SERVICE BULLETIN **Buell**[®]

B-024B

SAFETY RECALL CODE 0817 - REVISED SHOCK EYE

Since the release of the original bulletin (B-024), Buell Motorcycle Company has released a **new** shock absorber. This revised recall procedure applies to affected motorcycles that did not have the initial 0817 recall service performed. For motorcycles that have had the original 0817 recall service performed, refer to Bulletin B-035 for installation instructions.

Figure 2. New Shock Absorber Assembly

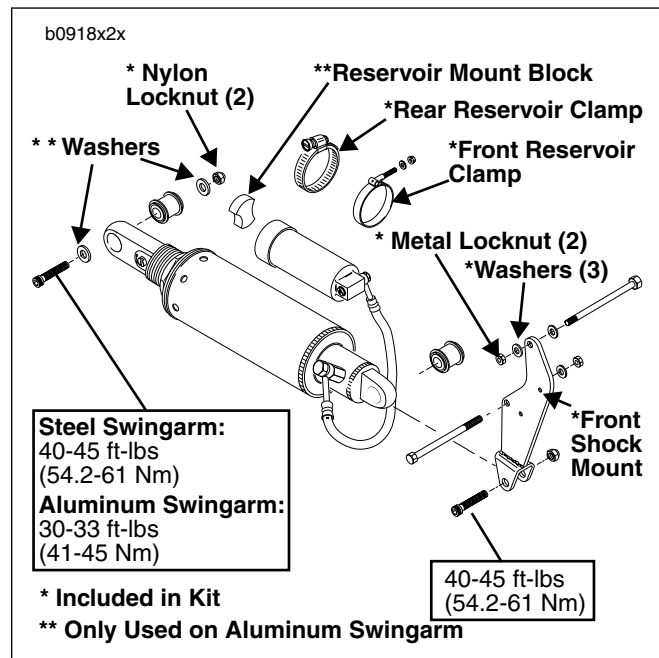
The new front shock mount **MUST** be used with the new shock absorber. The new shock is 1.77 in. (45 mm) shorter than the previous shocks and requires the new front mount to align and install properly.

1. See Figure 2. Install **new** front shock mount to crankcase with two **new** front shock mount bolts, washers, star washer (on 1997 M2, S3/S3T models only) and metal locknuts. Tighten bolts to 30-33 ft-lbs (41-45 Nm). **NOTE:** Top bolt goes in from the left side, bottom bolt goes in from right side. Bottom bolt does not use washer under bolt head. Star washer (only used on 1997 M2, S3/S3T models) goes on bottom bolt under the washer on the nut side. If exhaust was loosened during front shock mount removal, replace exhaust gaskets and reinstall exhaust. See appropriate Service Manual, Section 2 for instructions.

4. See Figure 2. Position **new** shock absorber from kit in mounting position.
5. Loosely install bolt, washers (aluminum swingarms only) and **new** locknut through rear shock eye and swing arm.
6. Loosely install bolt and **new** locknut through front shock eye and front shock mount.
7. **On 1996-1998 vehicles only:** Loosen header tie bar from collector.
8. Position front clamp over reservoir. Loosely install **new** front reservoir clamp to front shock mount (and install **new** header tie bar spacer between front shock mount and header tie bar on 1996-98 vehicles only) with **new** washer and **new** nylon locknut.
9. See Figure 3. Loosely install **new** rear clamp around reservoir and oil feed line.
10. **All Models:** Install **new** reservoir mount block between oil pump fitting and remote reservoir.

Figure 5. Preload and Compression Adjustments

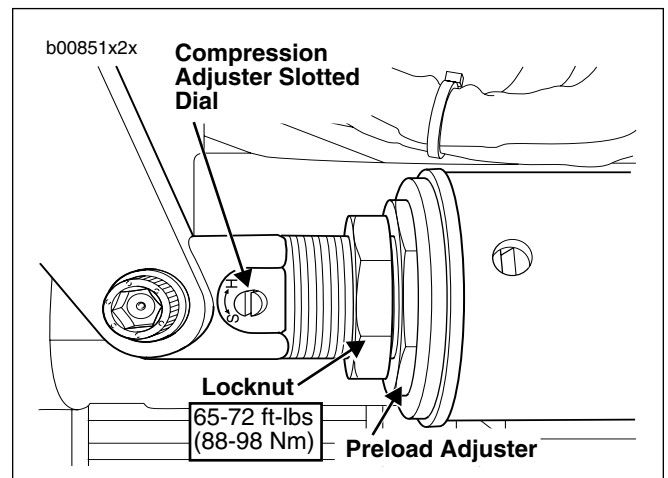
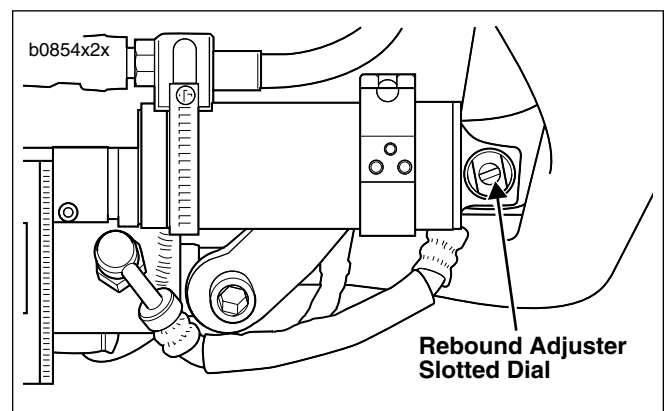
- See Figure 5. Set compression damping using the slotted dial on the shaft at the end of the shock. New factory setting is as listed below:
 - S1/S1W/M2 Models:** full damping minus 2.25 turns.

- S2/S2T Models:** full damping minus 2.5 turns.
 - S3/S3T Models:** full damping minus 2.5 turns.
 - See Figure 6. Set rebound damping using the slotted dial on the remote reservoir at the front of the shock. New factory setting is as listed below:

- S1/S1W/M2 Models:** full damping minus 1.5 turn.
 - S2/S2T Models:** full damping minus 1 turn.
 - S3/S3T Models:** full damping minus 1 turn.

Figure 7. Locknut Tightening Procedure

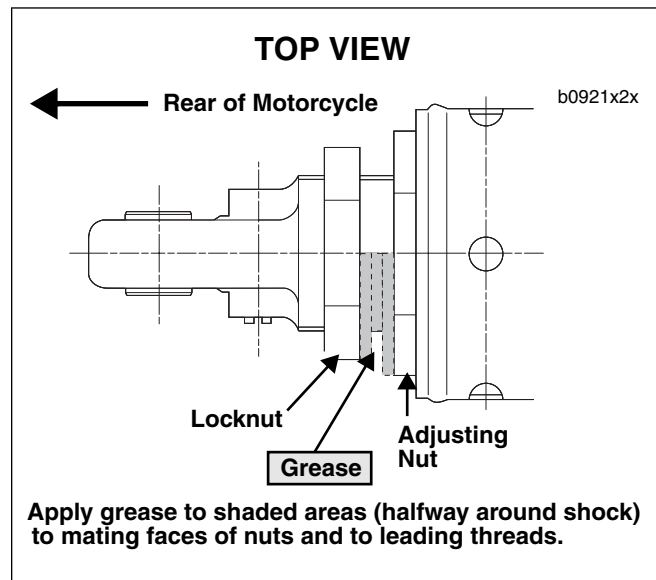
Since the release of the last bulletin (B-024A), the spring preload locknut tightening procedure has been modified (as covered in Bulletin B-037). This bulletin includes the new torque specification and tightening procedure.

- Using SHOCK PRELOAD ADJUSTING TOOLS (Part No. B-45110), hold adjusting nut in place with 60 mm ADJUSTING NUT WRENCH and tighten locknut to 65-72 ft-lbs (88-98 Nm) with 52 mm LOCKNUT CROW'S FOOT set at 90 degrees to the torque wrench.
- Wipe excess grease off of shock absorber.
